EGG-EA-5305

ADEQUACY OF STATION ELECTRIC DISTRIBUTION SYSTEM

VOLTAGES, ZION STATION, UNIT 1, DOCKET NO. 50-295,

TAC NO. 13007

ZION STATION  
UNIT ONE LINE DIAGRAM  
FIGURE 1

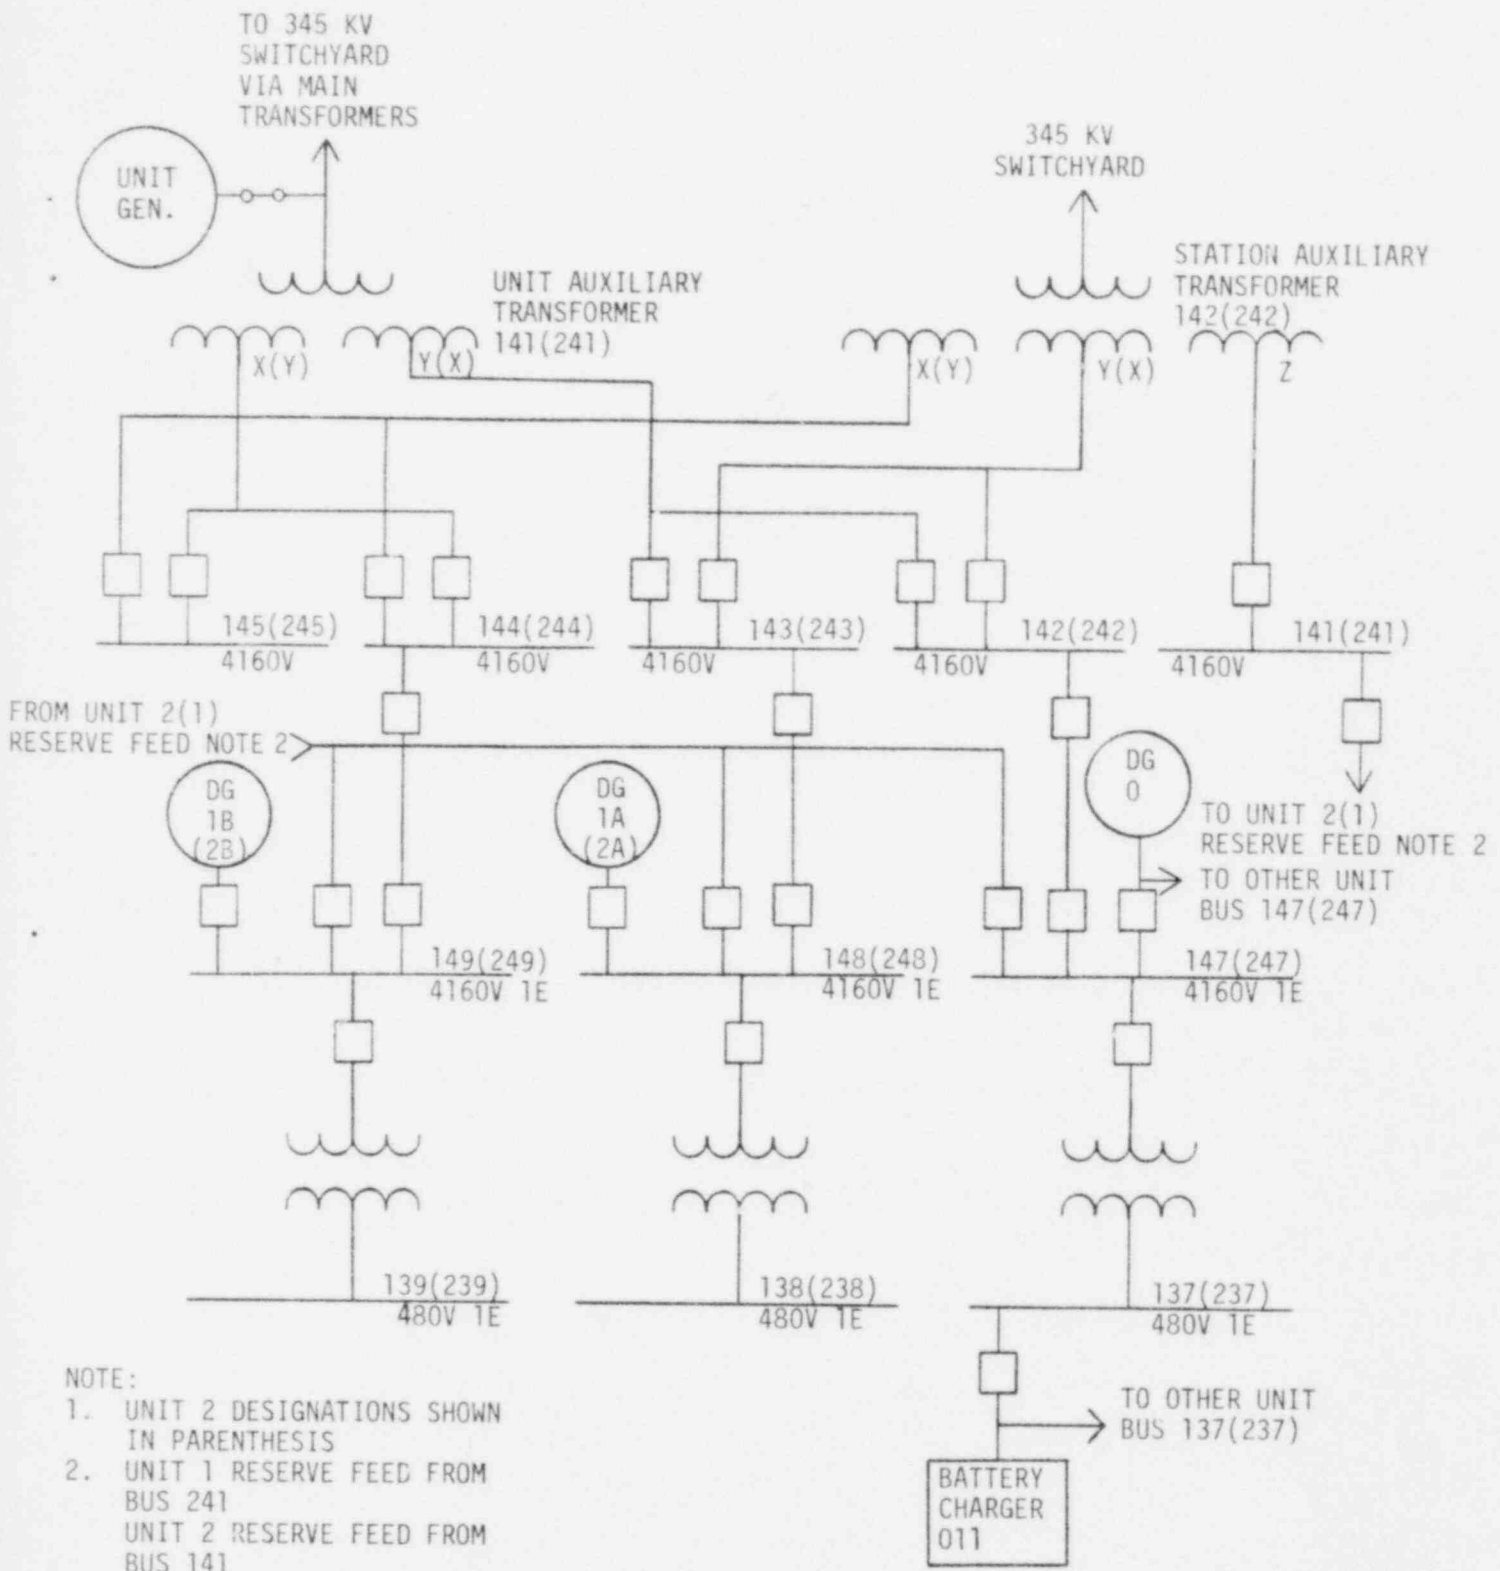
Figure 1 shows that, for Unit 1, the class 1E 4160V buses 147, 148, and 149 are normally supplied power from auxiliary buses 142, 143, and 144, respectively. These three buses are connected via two station auxiliary transformer (SAT) secondary windings (a single transformer) to the 345kV switchyard. The Unit 2 distribution system is identical except for bus and transformer numbers.

The CECO analysis shows that one of the three class 1E 4160V buses can be energized from the other unit SAT Z winding via an inter-tie connection that serves as a reserve source. The various breakers feeding each bus are interlocked so that no two sources can be connected together.<sup>3</sup> However, no interlocks exist to prevent two or three class 1E 4160V buses from being energized at the same time by the inter-tie connection.

The unit transformers are connected independently to the offsite power grid. CECo has shown that the Z winding of one SAT supplies adequate starting and operating voltages to one of the three 4160V class 1E buses of the other unit if the administrative procedure prohibiting the start of the electric steam generator feedwater pump is followed. CECo has not shown that more than one bus can be powered by this inter-tie.

1. CECo has not provided voltage analysis for the Z winding of one unit SAT supplying power to more than one class 1E power system of the other unit, CECo should put limiting conditions of operation in the Zion Technical Specifications to prevent the inter-tie from powering more than a single 480V class 1E bus. Alternatively, CECo could provide appropriate interlocking.
